SERVICE INFORMATION LETTER**SIL24-02**

SUBJECT: Pressurized Magneto Filter Assembly, Part No. 653386

PURPOSE: Availability of Improved Part

Figure 1. Pressurized Magneto with filter assembly (typical installation)

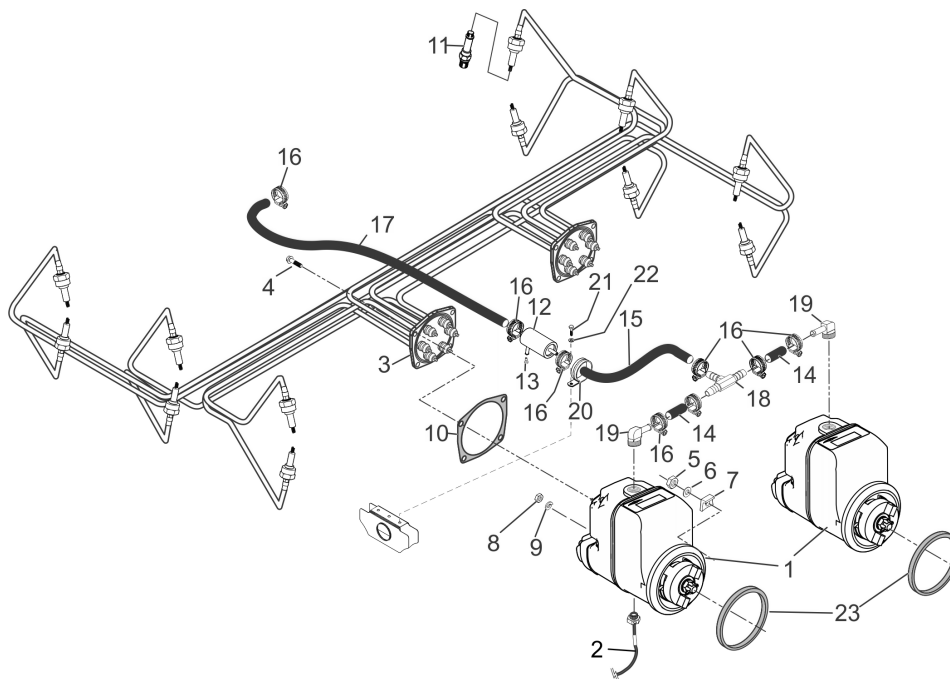
Field reports indicate some Part No. 653386 magneto pressurization filters (item 12 in Figure 1) are distorting from heat exposure during extended ground operation, leading to obstructed airflow through the pressurization hoses. As indicated above, restricted airflow through the pressurized magnetos can lead to internal component corrosion and accelerated magneto wear.

Figure 2. Magneto Pressurization Filter Assemblies

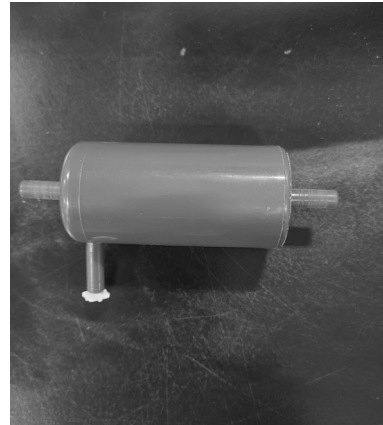
A new magneto pressurization filter assembly, Part No. 671855, with greater heat resistance, is available through our current distribution channels. The filter body is not transparent on the newer filter assembly.

Refer to the instructions in Section 6-4.15, Ignition System Inspection of M-0, Standard Practice Maintenance Manual for inspection instructions. If the magneto pressurization filter exhibits any indication contrary to the inspection instructions, replace the pressurization filter according to the “Magneto Filter Replacement” instructions in Section 10-5.5 of M-0, Standard Practice Maintenance Manual.
